# TECHNICAL BULLETIN

<b>ZF 4HP 24 E9 Automatic Transmission – Poor Shift Quality in R, 3-4</b>	<b>44-27</b>
<b>MODEL Sedan (4.0L) Range 1990 - 94 MY DATE 6/95 XJS (4.0L) Range 1993 - 94 MY Up to trans. serial no. 158813</b>

ILLUSTRATION 2

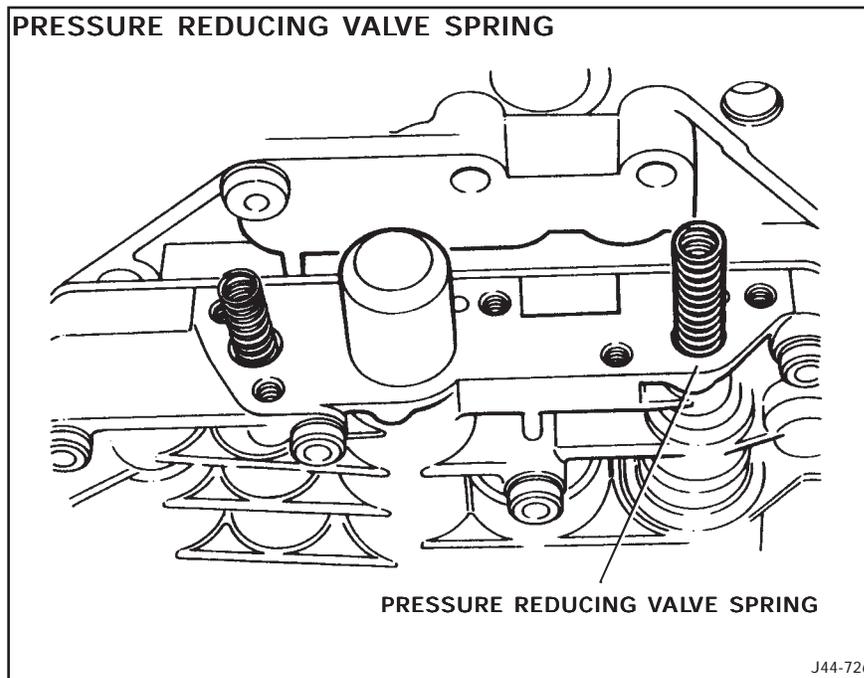
8. Remove and discard the pressure reducing valve spring from the right side location (Illustration 2).
9. Make sure that the pressure reducing valve behind the right side spring moves freely in its bore.

10. Install a new spring, part no. NHD 5601AA, into the bore of the pressure reducing valve.
11. Reinstall the valve body end plate and the clip for the speed sensor harness. Thread, but do not fully tighten, the retaining bolts.
